October 22, 2019

Re: Larimer Pits Substitute Water Supply Plan (Plan ID 2915; WDID 0402525)
Amendment
DRMS File No. M-1974-069 (WDID 0403005)
Sections 15, 16, 17, T5N, R69W, 6th P.M.
Water Division 1, Water District 4, Larimer County

Approval Period: October 22, 2019 through July 31, 2021

Figure 1 Loveland Ready-Mix Property Larimer Pits Site

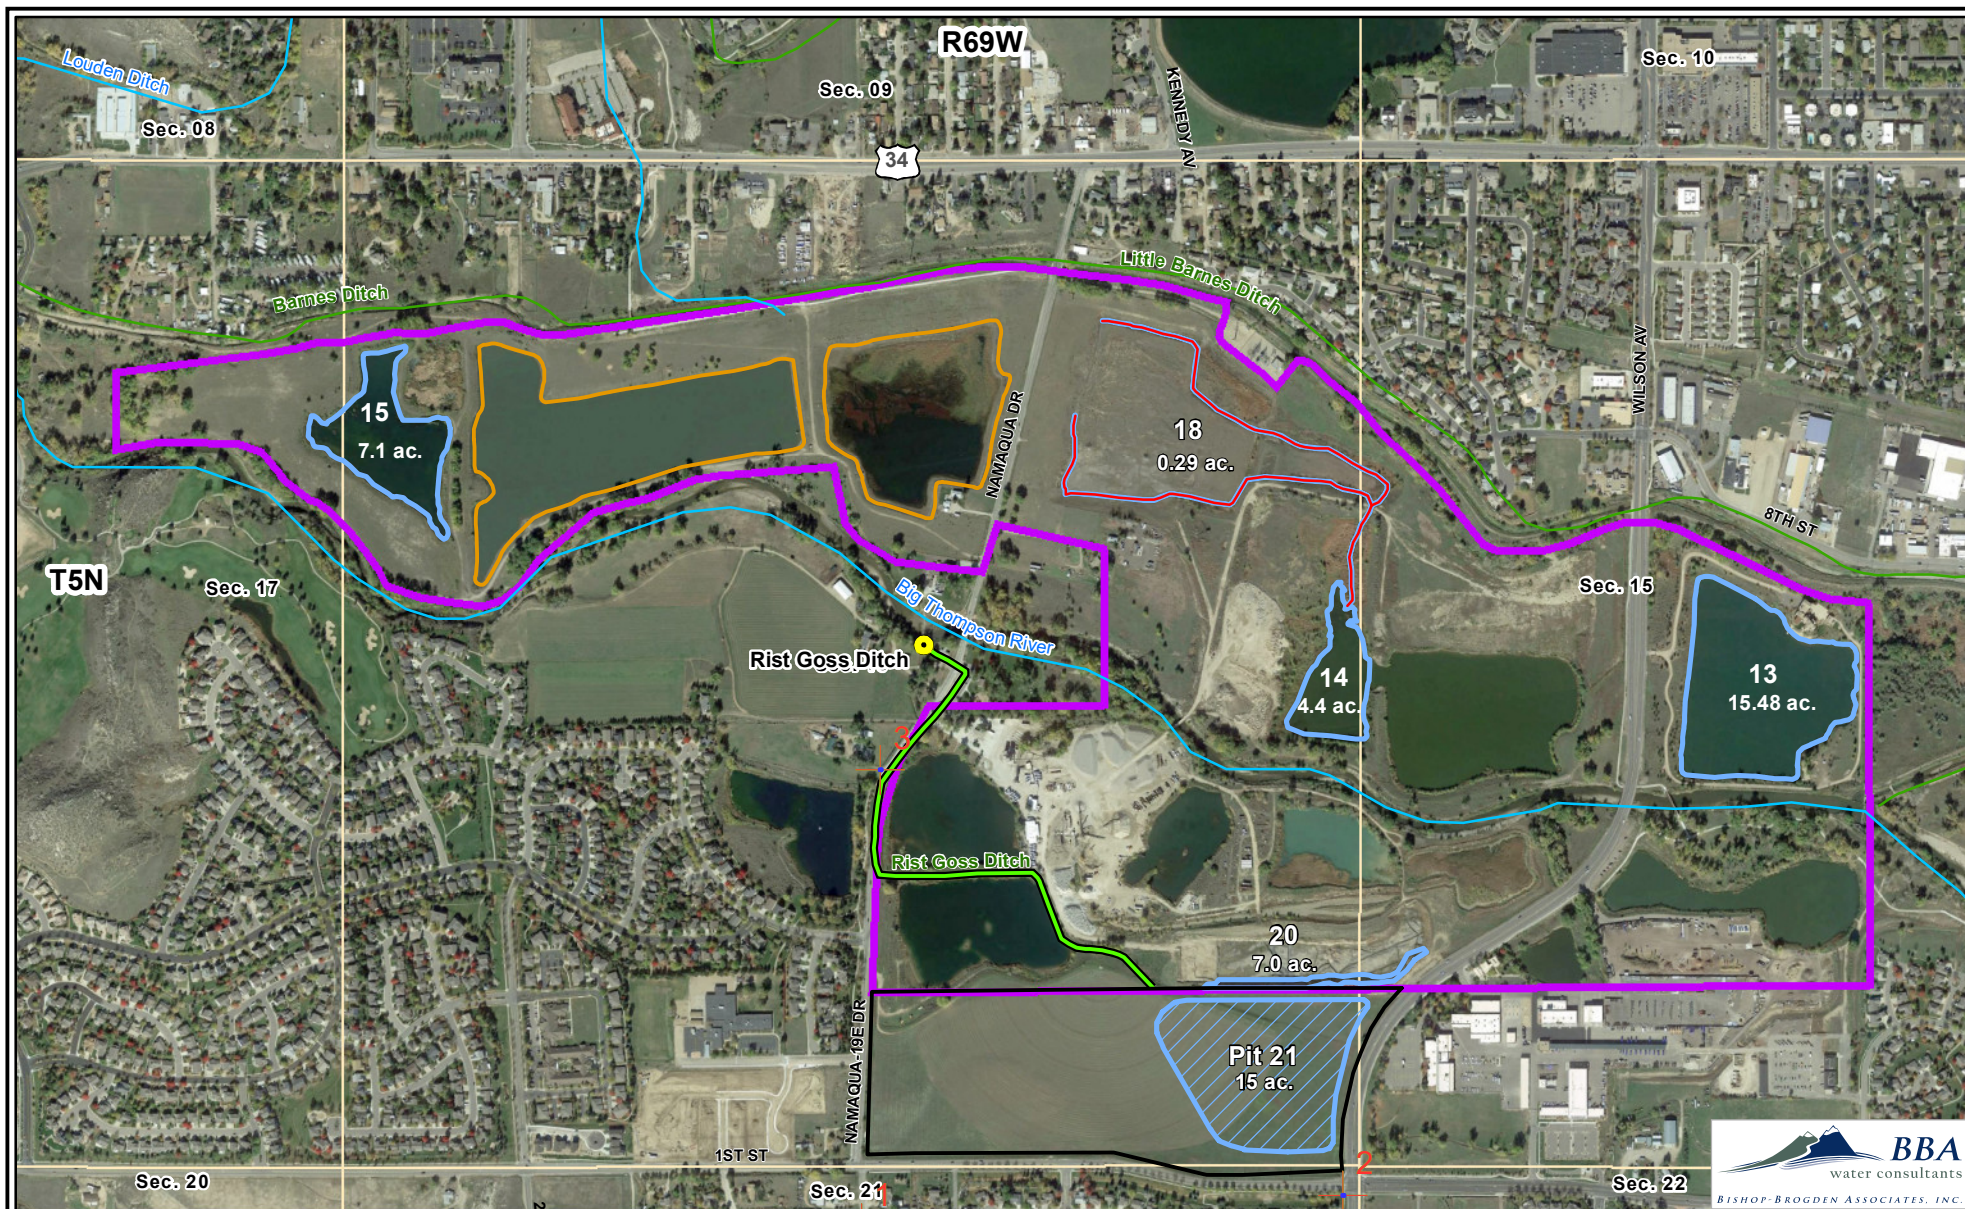
LRM's Larimer Pits site is located in portions of Section 15, 16, and 17, T5N, R69W, 6th P.M., Larimer County, as shown in the attached Figure 1. The original site consisted of 20 gravel pits, five of which were completed prior to 1981, seven that are augmented under Case No. W-7412, four that have been backfilled, two that have been lined and decreed for storage, and five unlined pits that are partially augmented under Case No. 00CW142. The augmentation plan decreed in Case No. 00CW142 is limited to replacing depletions associated with evaporation from exposed surface areas and mining uses at Pit Nos. 13, 14, 15, 18 and 20. Pit 21 was added to the reclamation plan in Amendment AM03 and is not included as an augmented structure in Case No. 00CW142. During August of 2019, LRM discontinued dewatering at the unlined Pit No. 20, which is resulting in depletions due to lagged dewatering depletions no longer being offset by the water returned to the stream system,

The LRM Ponds 1 and 2 are located within the Larimer Pits property boundary as shown in Figure 1, and deliver water to the Big Thompson River upstream of the location of lagged depletions resulting from Pit No. 20 and upstream of the Rist and Goss Ditch headgate. There are no intervening rights between the location of the reservoir releases and the ditch headgate, and transit loss should be minimal. The lagged dewatering depletions and water that is stored out of priority through infiltration will be replaced by releases from storage in LRM Ponds 1 and 2. Daily inflows into Pit No. 20 will be less than LRM's available release rates of its augmentation water in LRM Ponds 1 and 2, which LRM currently estimates to be 2 cfs. If for any reason sufficient water is not able to be replaced by LRM's storage releases, LRM will also have the ability to release all out-of-priority inflows from Pit No. 20 by continuing to dewater to the level reached while in priority or augmented.
